12 July 2001
DCS-NRC-000053
Response Requested: *No*

As requested in your 08 June 2001 letter, please find attached our response to your request for additional information on the Mixed Oxide Fuel Fabrication Facility Environmental Report. In addition to the responses, ten compact discs are enclosed with this letter. Each compact disc contains the responses, a list of the attachments referenced in the responses, the attachments arranged by question and response, and proposed revisions to the Environmental Report text. DCS is not revising the Environmental Report at this time, however, DCS plans to revise it later this year to incorporate these changes.

- Enclosures: 1.) Responses to MFFF ER Request for Additional Information
- 2.) A Compact Disc containing a copy of the responses, a list of the attachments referenced in the responses, the attachments arranged by question and response and proposed revisions to the Environmental Report text.

Figure 27-1 Site Infrastructure Development Concept

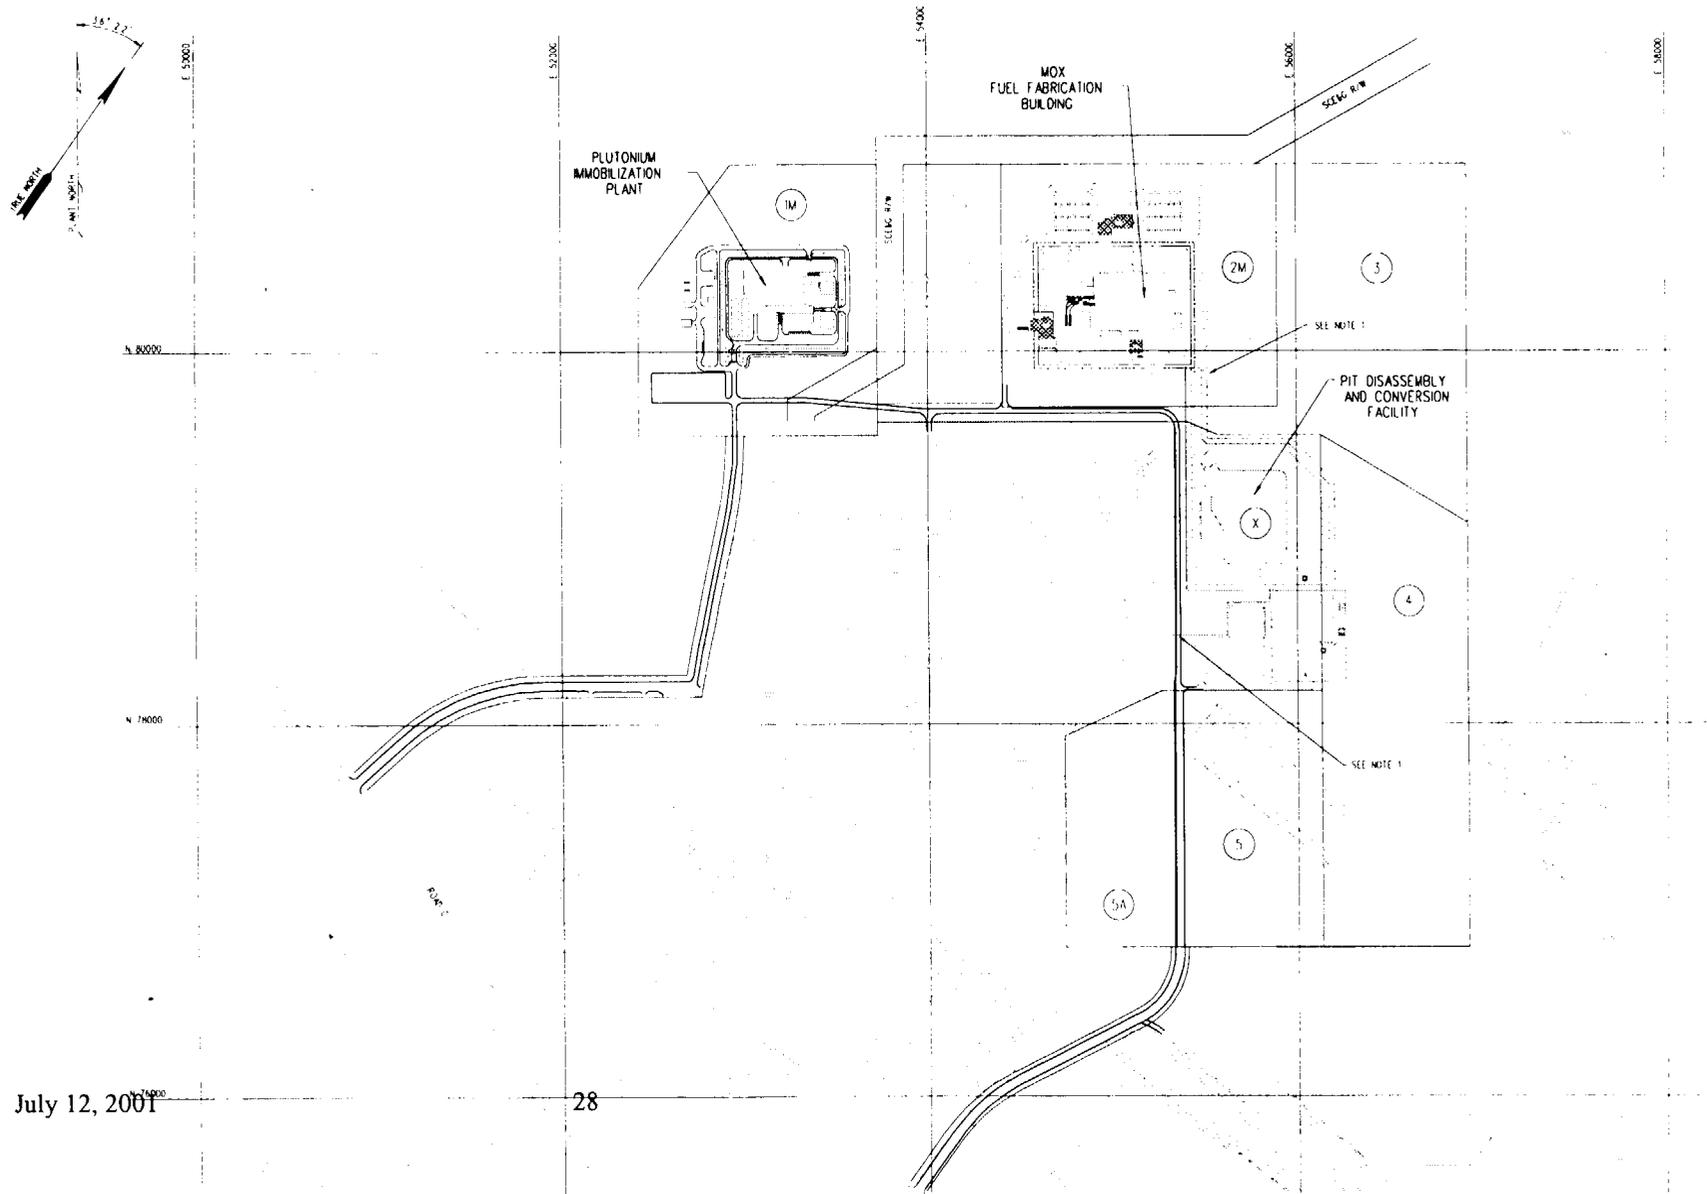
1. Section 1.2.1, F-Area Infrastructure Upgrades. Section 1.2 of the ER refers to augmented de-ionized water supplies necessary to support the MOX FFF. Explain what is meant by “augmented water supplies.” If augmentation requires construction of new water treatment facilities, indicate their size and show locations on a site map.

Because only 1,300 to 1,500 feet of the proposed roadway (in two pieces) is not in previously cleared road rights-of-ways, the total land area expected to be disturbed in connection with road work is less than 5 acres. See attached Figure 27-1, Site Infrastructure Development Concept.
